Traffic Calming (Speed Humps) - Van Allan Road

Date: June 25, 2024

From: Director, Traffic Management, Transportation Services

**RE: Location (Van Allan Road between Confederation Drive and [Steventale Drive](#))
Speed Hump Investigative Summary**

Attachment 2: Speed Hump Locations Plan - Van Allan Road - TC-288

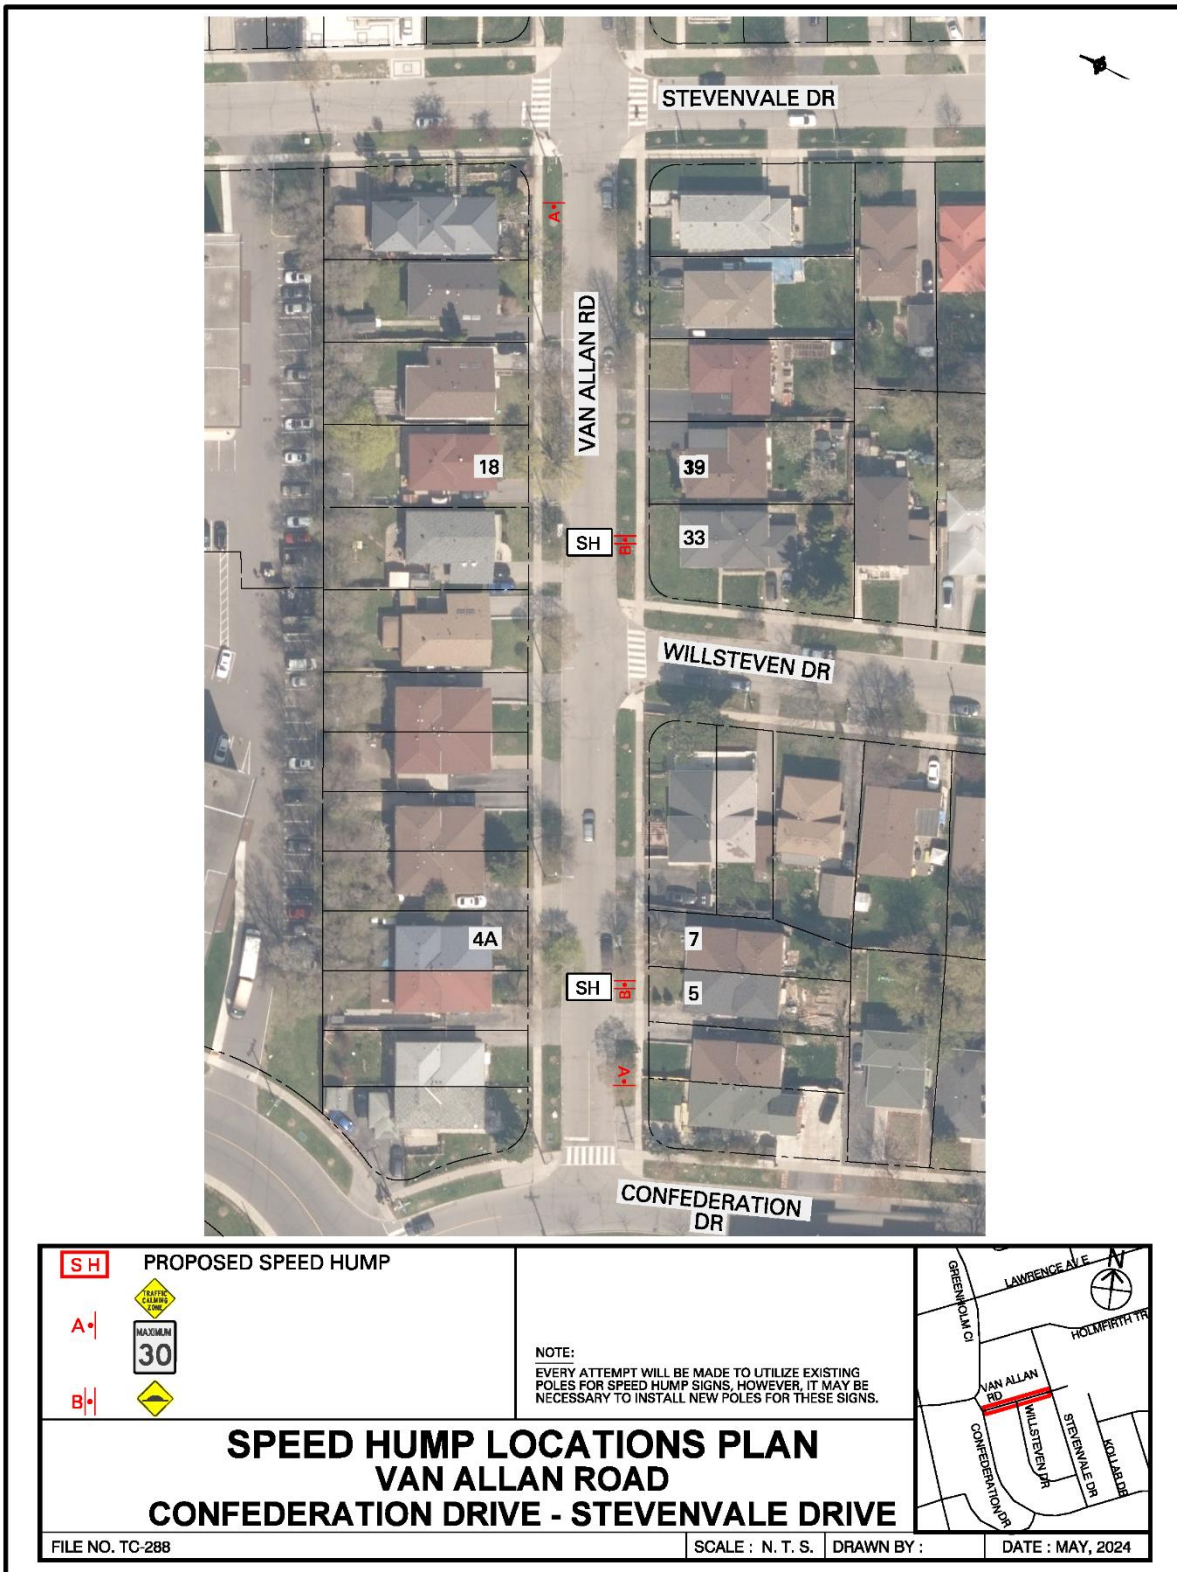
Toronto Fire Services does not support this proposed speed hump installation as it may negatively impact service delivery. The physical restrictions imposed by speed humps have a greater impact on fire vehicles. Response time increases with every obstacle encountered responding to any emergency incident and the cumulative impact of several speed humps can increase responses times.

Toronto Fire Services is supportive of initiatives that improve safety for all citizens of and visitors to the City of Toronto. However, careful consideration must be given to accepting a delay to emergency response vehicles as a compromise to combat the risks presented by all vehicular traffic. Our recommendation is that non-physical measures be considered and evaluated to determine if desired results can be obtained without imposing a physical obstacle to emergency vehicles.

Van Allan Road appears to primarily service the residents that reside on the roadway and would not impact response times for other community members. It is important that the applicant understand that the installation of traffic calming devices will reduce the speed that emergency vehicles travel when responding to emergencies on roadways where they are installed.
